Technical Service Bulletin: tsb100575

Released Date: 04-Oct-2011

New Intake Valves

Figure 1: New K38 and K50 Intake Valve, Part Number 3631950

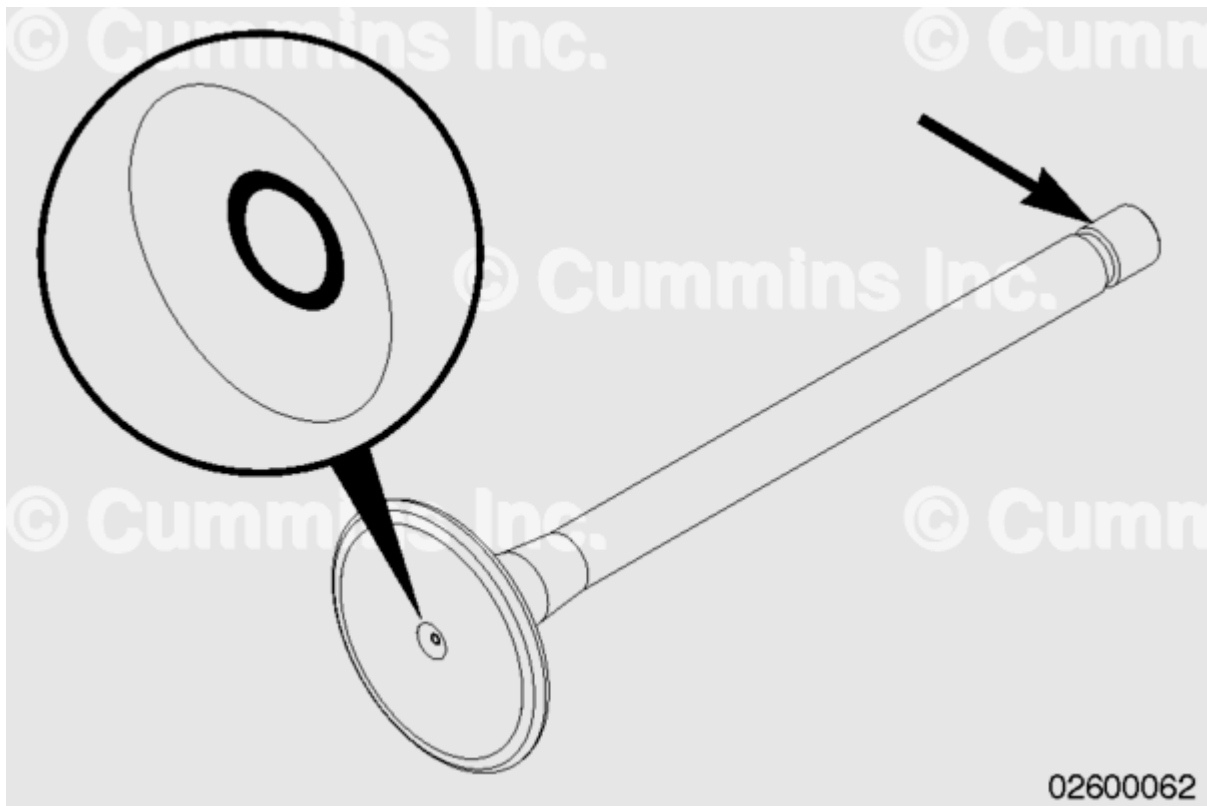
- The new K38 and K50 Sursulf intake valve, Part Number 3631950, is a direct replacement for intake valve Part Number 3052820.
- The new intake valve can be identified by the letter 'O' forged into the bottom, center of the valve and by the part number laser-etched into the stem, above the collet groove. See Figure 1.

Figure 2: New QSK45 and QSK60 Intake Valve, Part Number 3171769

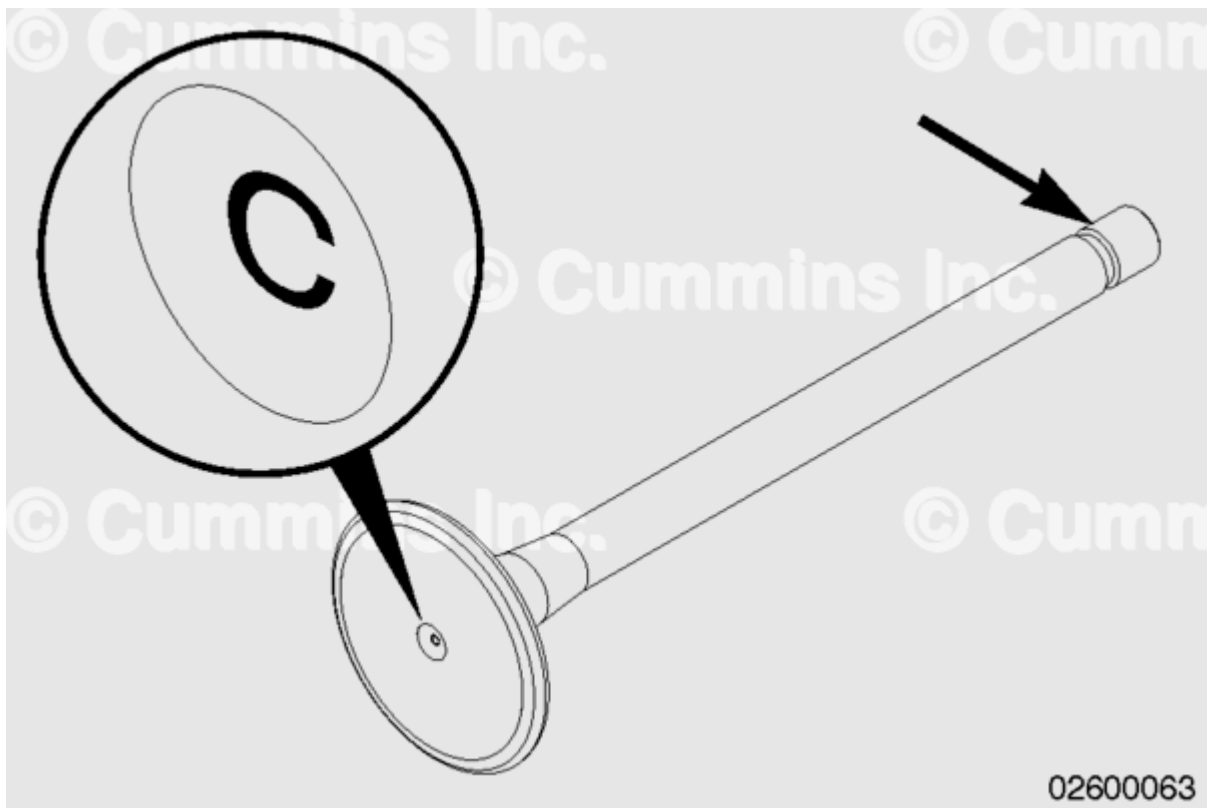
- The new QSK45 and QSK60 Sursulf intake valve, Part Number 3171769, is a direct replacement for intake valve Part Number 4016438.
- The new intake valve can be identified by the letter 'C' forged into the bottom, center of the valve and by the part number laser-etched into the stem, above the collet groove. See Figure 2.
